**BRADBURY PLACE TOWNHOMES**  
A PORTION OF SECTION 3, TOWNSHIP 19N, RANGE 04 E, W.M.  
CITY OF PUYALLUP, PIERCE COUNTY, WASHINGTON

SHEET TITLE: COVER SHEET AND HORIZONTAL CONTROL

PROJECT:	20-223
DWG NAME:	20-223 C
SHEET	REV.
C1	0
1 OF 28

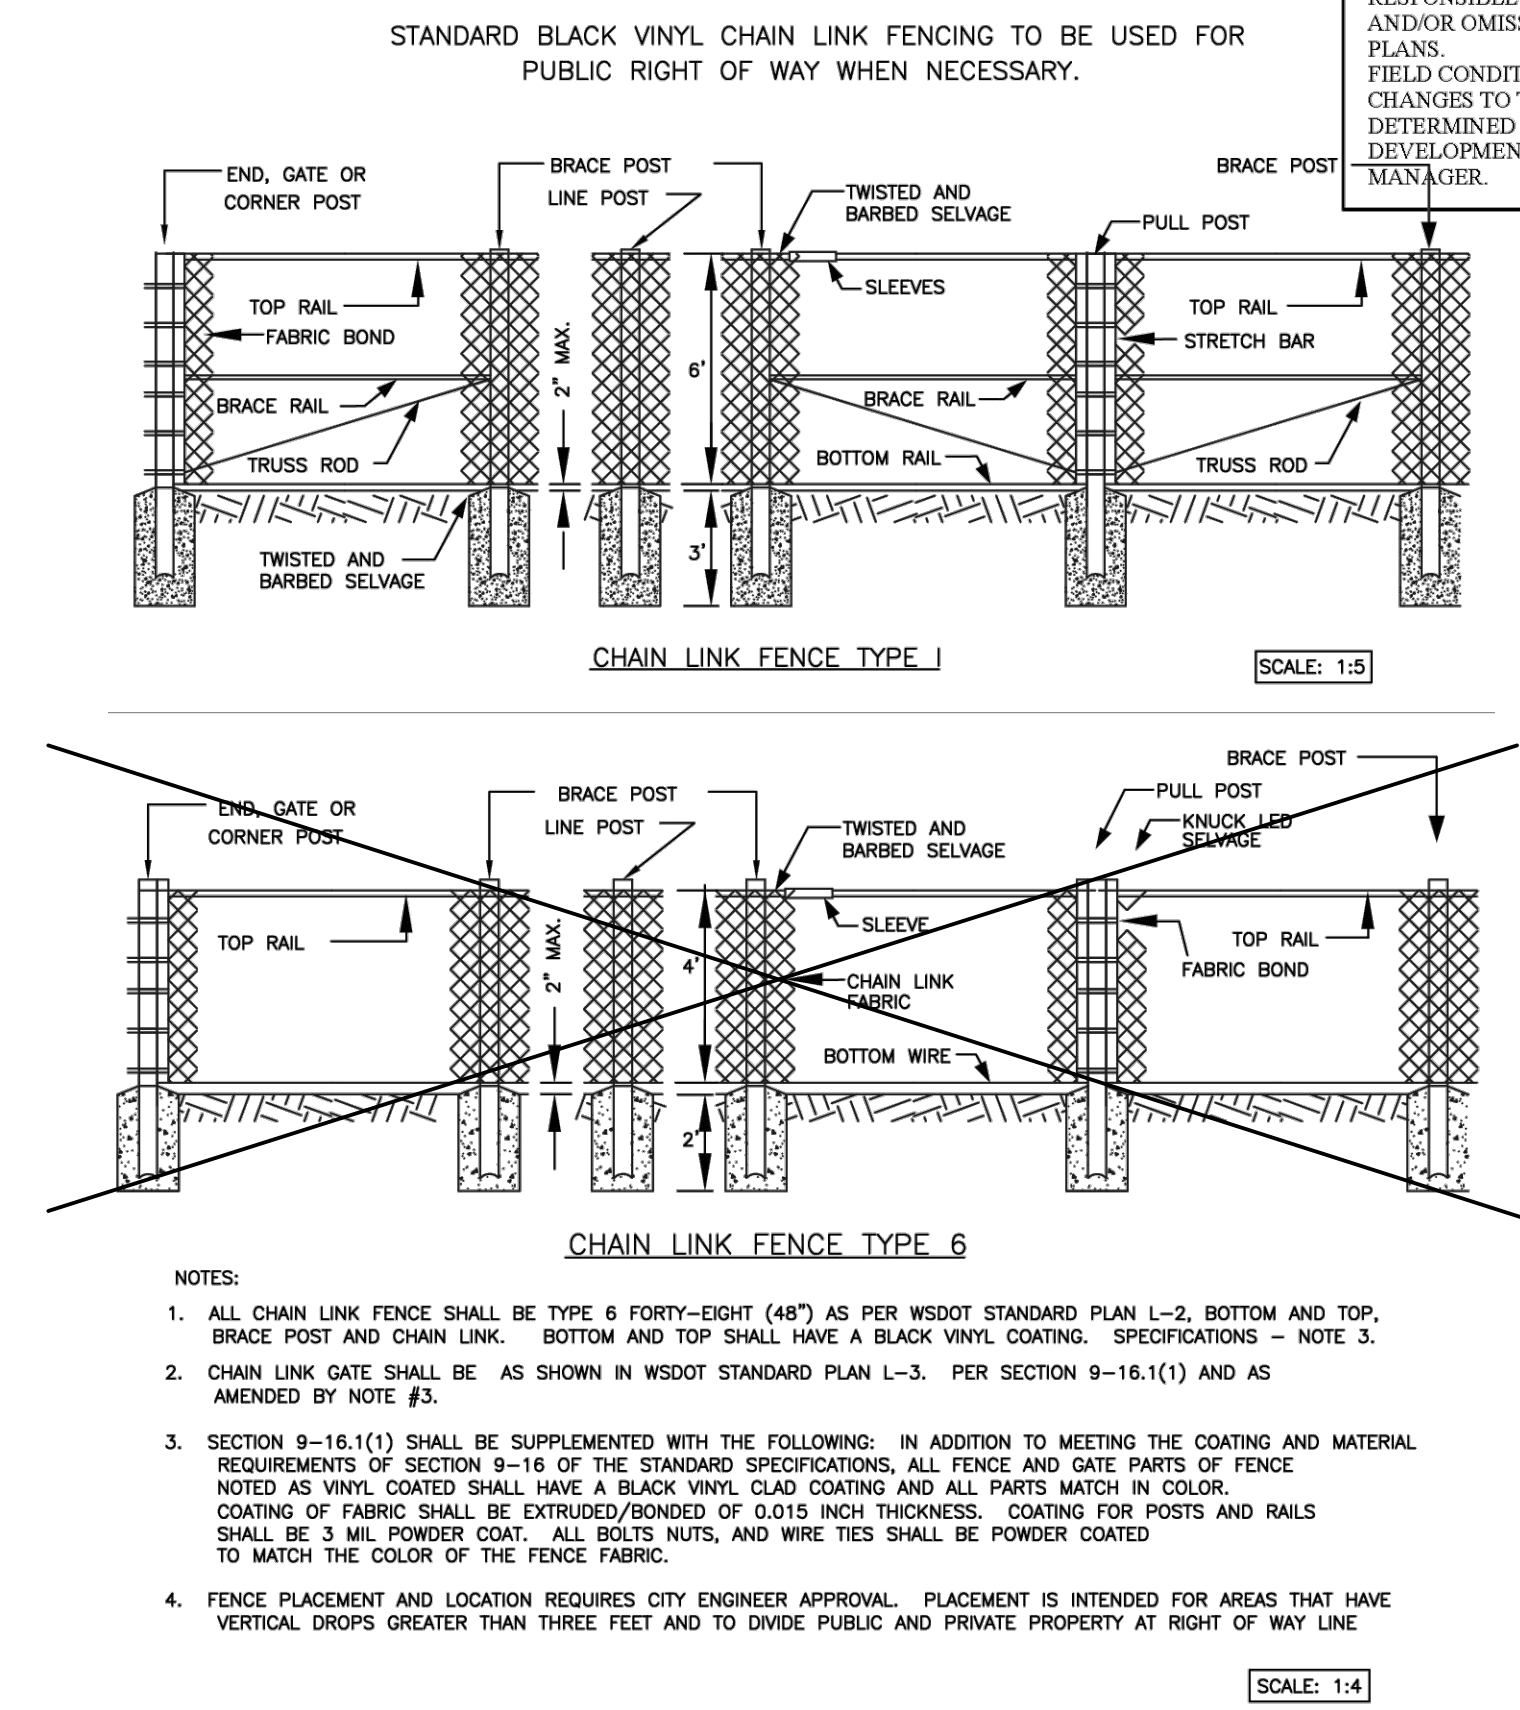
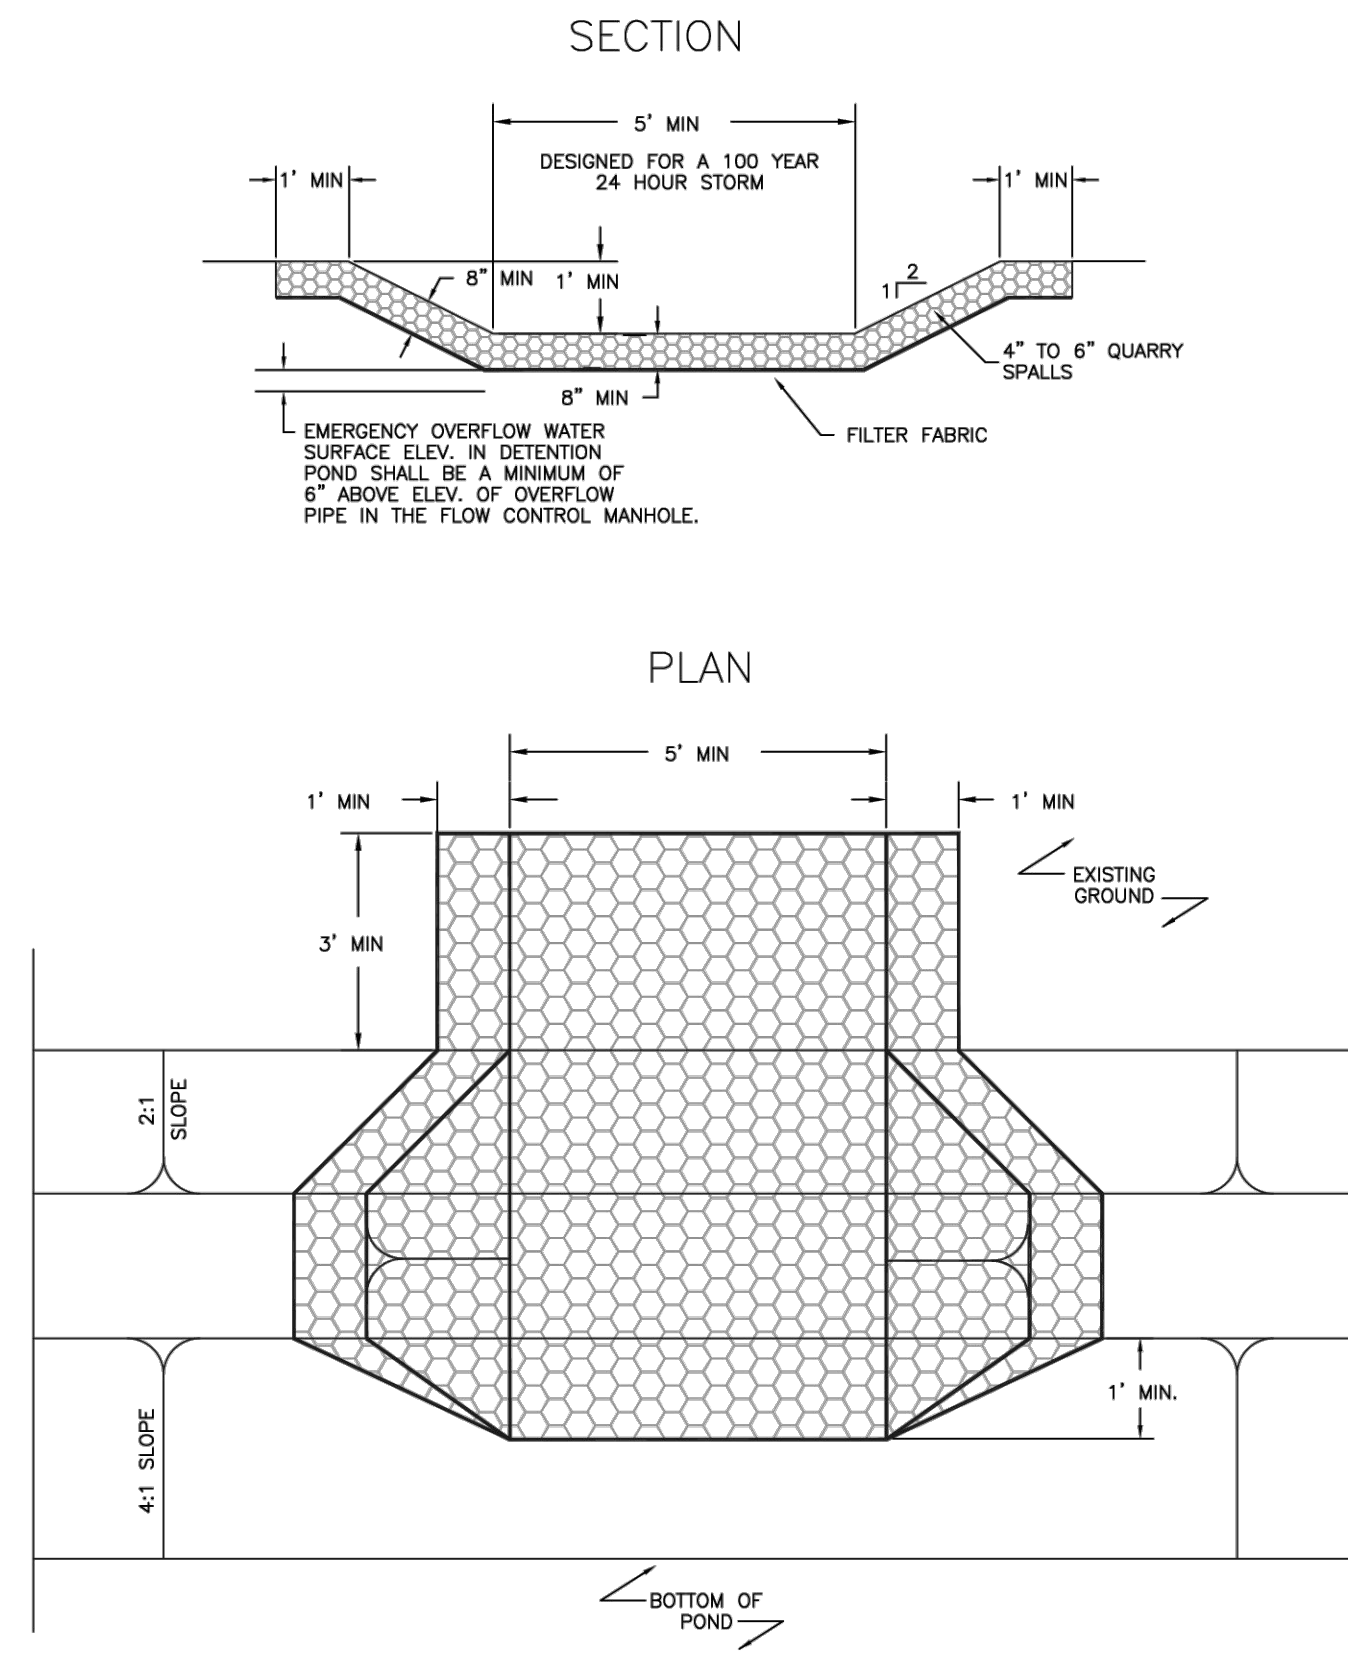
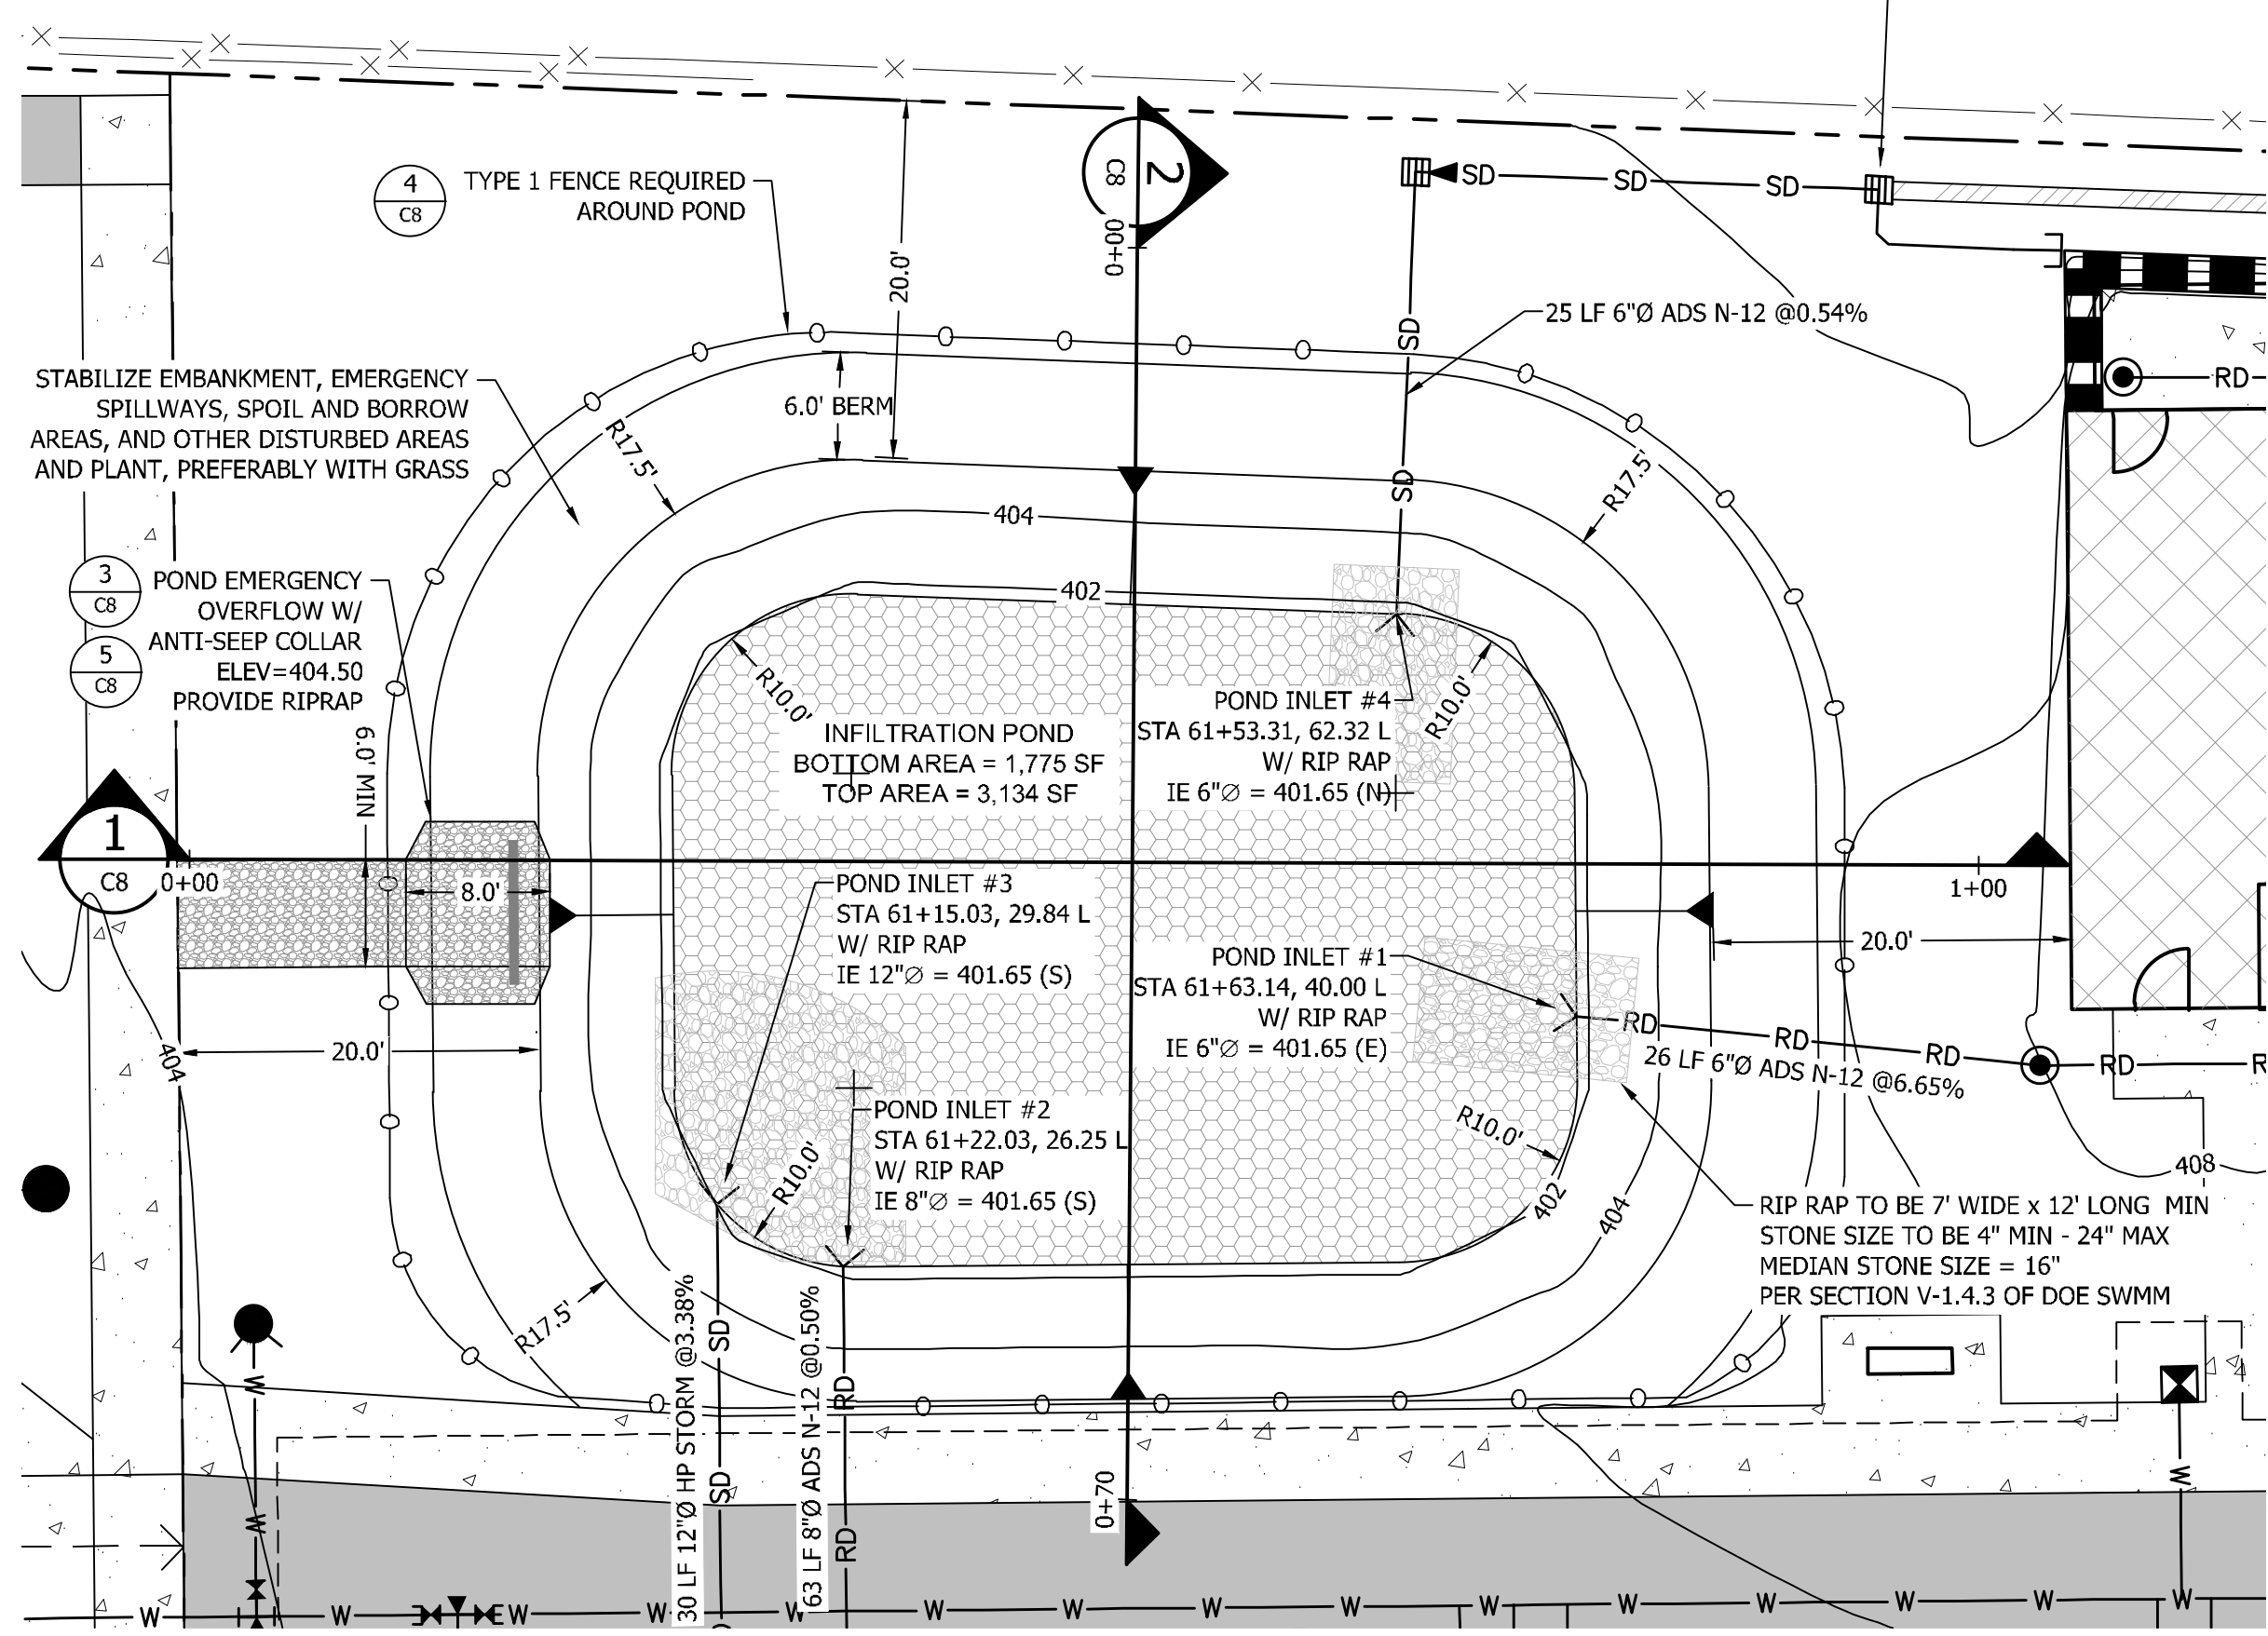
Note that the private storm mains are labeled as HP. Per City standards, "Polypropylene Pipe (PP) shall be dual walled, have a smooth interior and exterior corrugations and meet WSDOT 9-05.24(1). 12-inch through 30-inch pipe shall meet or exceed ASTM F2736 and AASHTO M330, Type S, or Type D." [Civil Plans, pg. 8]
